Subject: Issuance of Amendment No. 5 to Facility Operating License No. NPF-38
for Waterford 3

ISSUANCE OF AMENDMENT NO. 5 TO FACILITY OPERATING
LICENSE NP. NPF-38 FOR WATERFORD 3

AMENDMENT TO FACILITY OPERATING LICENSE

Amendment No. 5
License No. NPF-38

FIGURE 3.2-1a

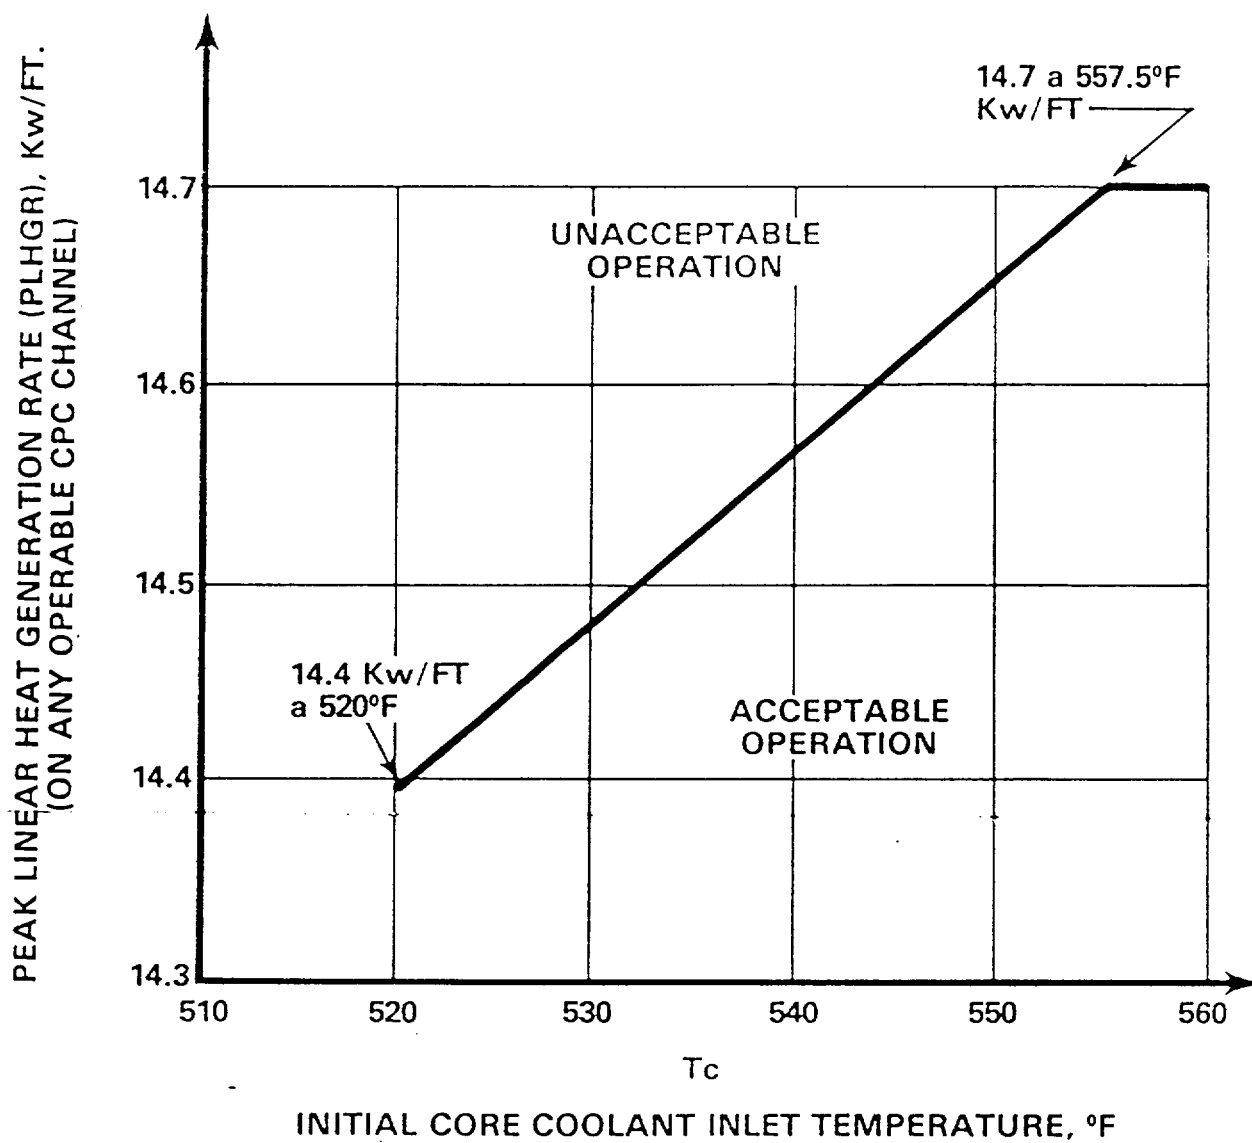
- a. Maintaining COLSS calculated core power less than or equal to COLSS calculated core power operating limit based on linear heat rate (when COLSS is in service); or
- b. Operating within the region of acceptable operation of Figure 3.2-1a using any operable CPC channel (when COLSS is out of service and either one or both CEACs is operable).
- c. Automatically by CPC (when COLSS is out of service and neither CEAC is operable).

1. COLSS calculated core power exceeding COLSS calculated core power operating limit based in linear heat rate; or
2. When COLSS is out of service, operation outside the region of acceptable operation in Figure 3.2-1a;

The additional uncertainty terms included in the CPC's for transient protection are credited in Figure 3.2-1a since this curve is intended to monitor the LCO only during steady state operation.

The proposed change modifies the Technical Specifications to incorporate the results of the Waterford 3 COLSS out-of-service analysis. The change revises Technical Specifications 3.2.1, "Linear Heat Rate", 3.2.4, "DNBR Margin", 3.2.7, "Axial Shape Index", and the associated Bases. The change also adds Figure 3.2-1a "Allowable Peak Linear Heat Rate vs Tc for COLSS Out-of-Service"; deletes Figures 3.2-2 "DNBR Margin Operating Limit Based on COLSS" and replaces it with "DNBR Margin Operating Limit Based on CPC's (COLSS Out-of-Service, CEACs Operable)"; revises Figures 3.2-3 "DNBR Margin Operating Limit Based on CPC's (COLSS Out-of-Service, CEACs Inoperable)"; and revises Action 6.b.1 of Table 3.3-1.

The Core Operating Limit Supervisory System (COLSS) is normally used to monitor linear heat rate, DNBR margin, and axial shape index. However, whenever COLSS is out of service, the CPCs are used to perform the safe monitoring function. Since the CPCs use excore neutron detectors and are required to provide protection during certain transients and accidents, the CPC uncertainties and margins are more limiting than those of COLSS, which uses incore neutron detectors. These extra conservatisms built into CPC for transient protection are not all required when the CPCs are being used for monitoring. The licensee has credited these conservatisms in the COLSS Out-of-Service limits of Technical Specifications 3.2.1, 3.2.4, and 3.2.7 when the CPC is being used for monitoring. These conservatisms provide approximately 10% LHR and 12% DNBR power margin credits which have been translated into COLSS Out-of-Service LCO adjustments in the proposed Technical Specification changes. Since these conservatisms are not taken from the CPCs but rather are credited in the COLSS Out-of-Service limits of the Technical Specifications, the CPC transient protection is not affected. However, these credits will have to be re-evaluated when the CPC changes associated with the CPC Improvement Program (CIP) described in CEN-308-P, "CPC/CEAC Software Modifications to the CPC Improvement Program" are implemented at Waterford Unit 3, since some CPC penalties were reduced as a part of the CIP. Therefore, the staff concludes that the licensee's proposal to take credit for the conservatisms built into the CPCs when they are being used in a monitoring function, is acceptable.

FIGURE 3.2-2

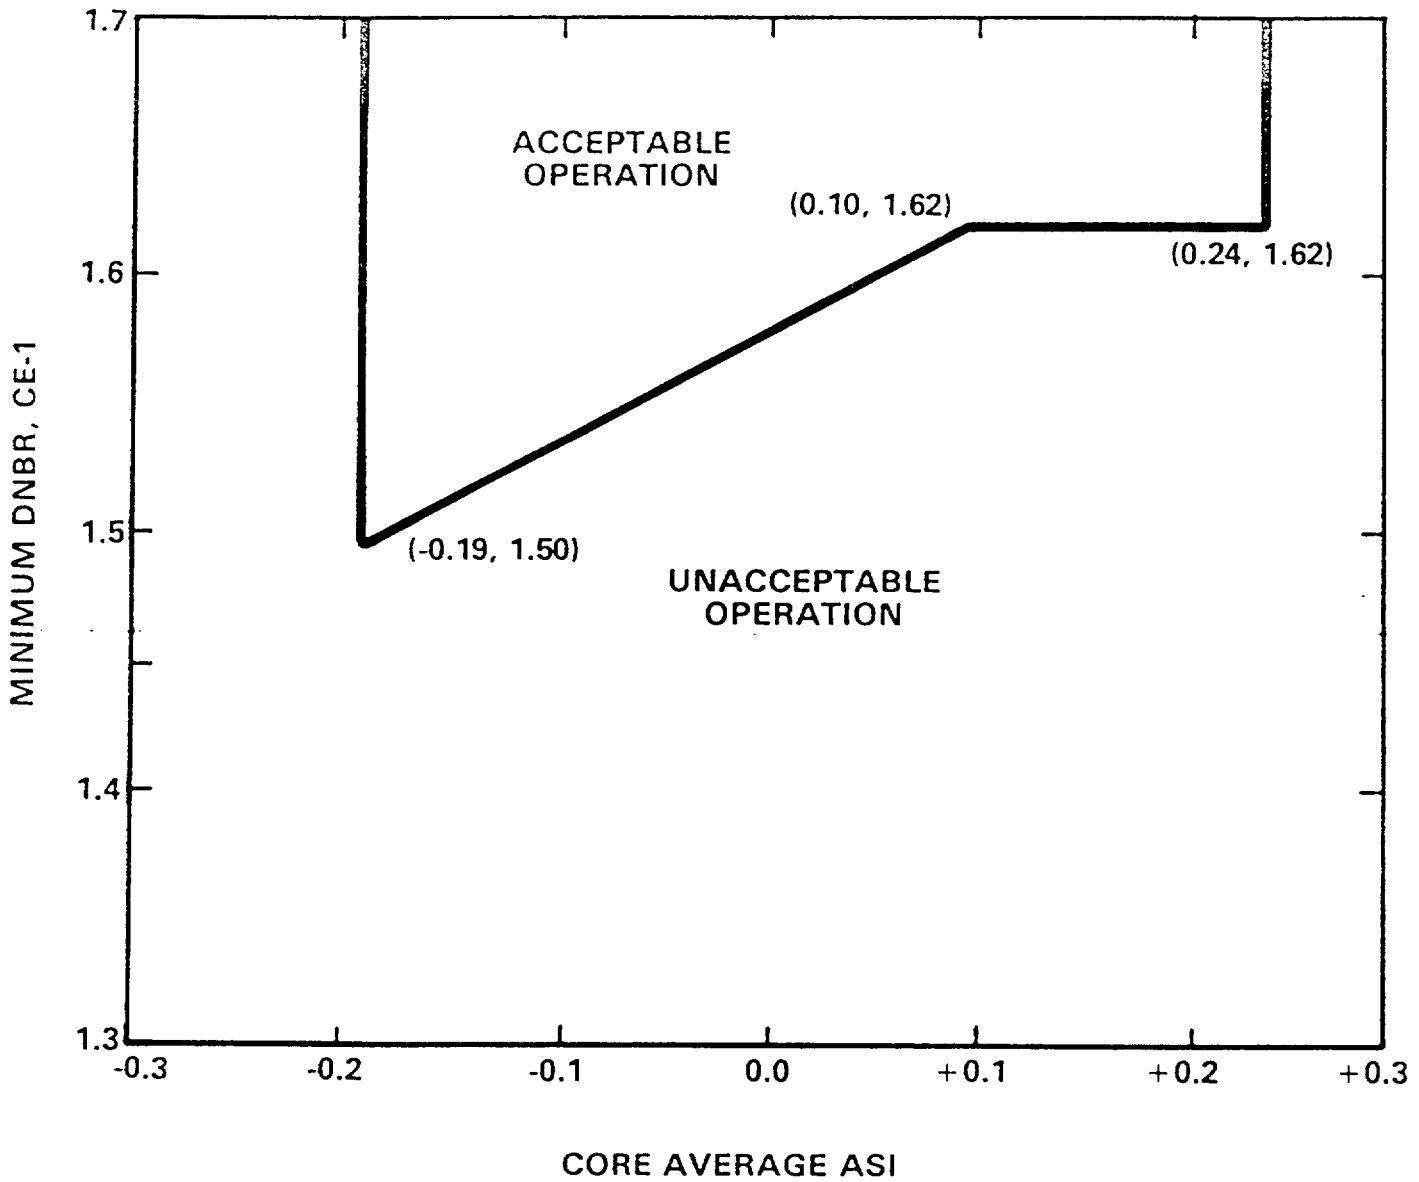
1. As indicated by COLSS calculated core power exceeding the appropriate COLSS calculated power operating limit; or
2. With COLSS out of service, operation outside the region of acceptable operation of Figure 3.2-2 or 3.2-3, as applicable;

FIGURE 3.2-3

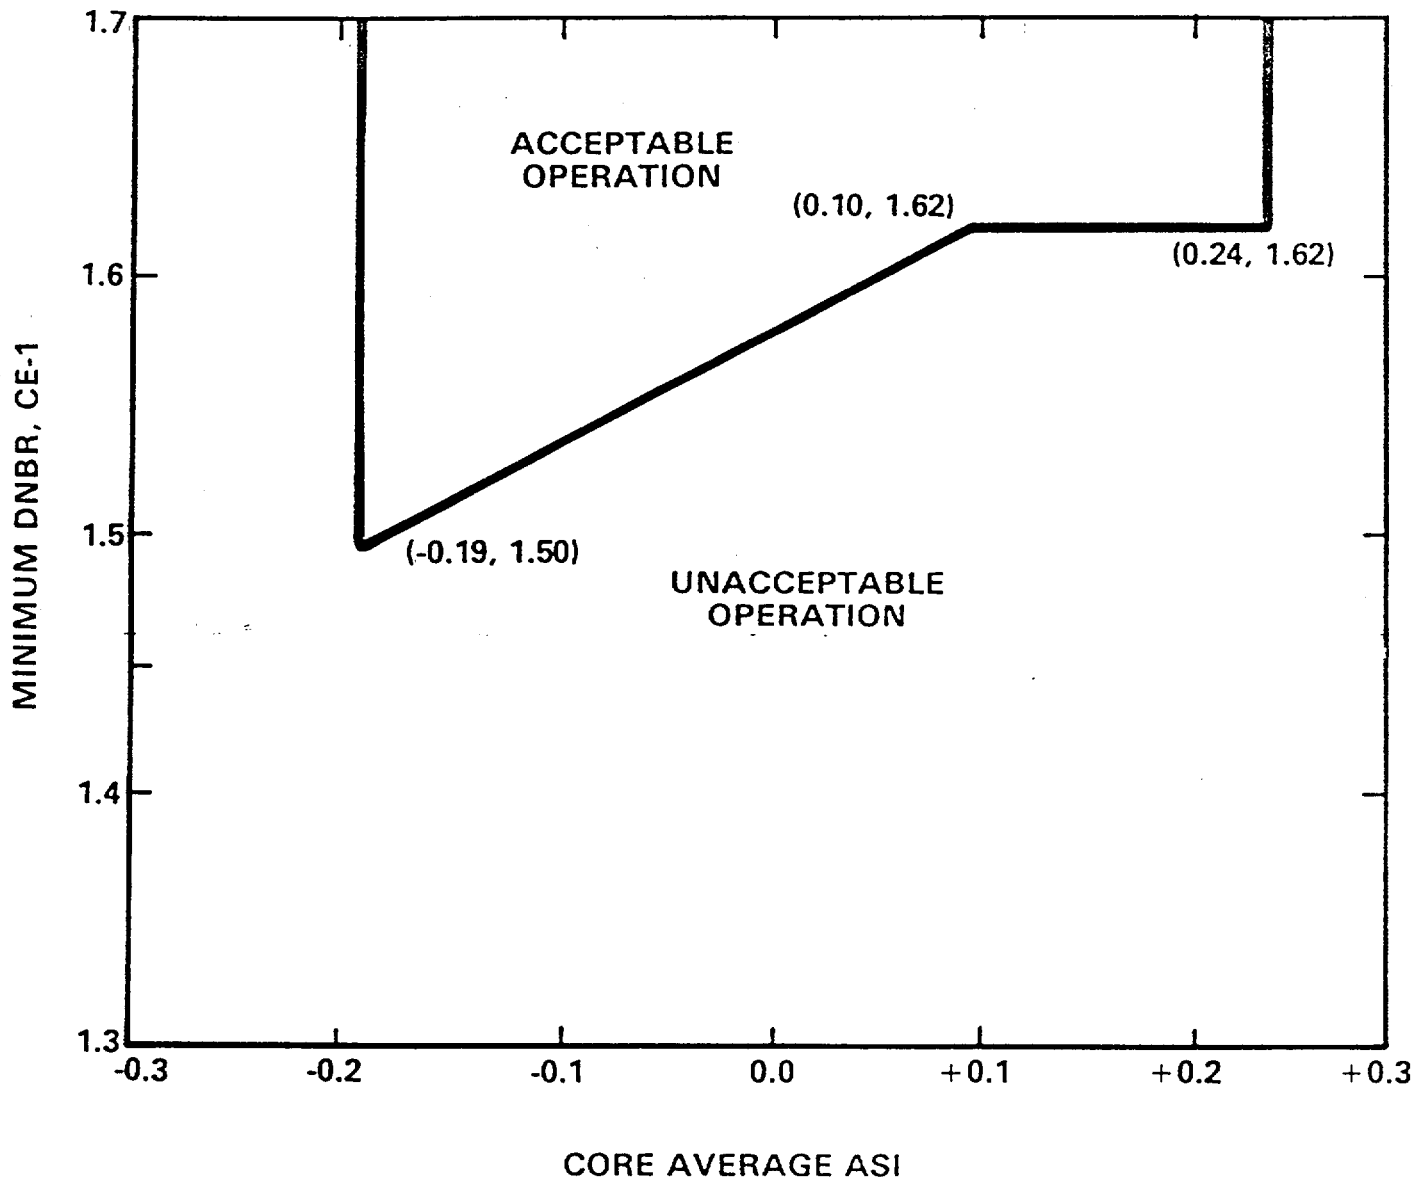
4.2.4.2 The DNBR shall be determined to be within its limits when THERMAL POWER is above 20% of RATED THERMAL POWER by continuously monitoring the core power distribution with the Core Operating Limit Supervisory System (COLSS) or, with the COLSS out of service, by verifying at least once per 2 hours that the DNBR, as indicated on any OPERABLE DNBR channels, is within the limit shown on Figure 3.2-3.

Parameters required to maintain the margin to DNB and total core power are also monitored by the CPCs. Therefore, in the event that the COLSS is not being used, operation within the limits of Figure 3.2-3 can be maintained by utilizing a predetermined DNBR as a function of AXIAL SHAPE INDEX and by monitoring the CPC trip channels. The above listed uncertainty and penalty factors plus those associated with startup test acceptance criteria are also included in the CPCs which assume a minimum core power of 20% of RATED THERMAL POWER. The 20% RATED THERMAL POWER threshold is due to the neutron flux detector system being less accurate below 20% core power. Core noise level at low power is too large to obtain usable detector readings.
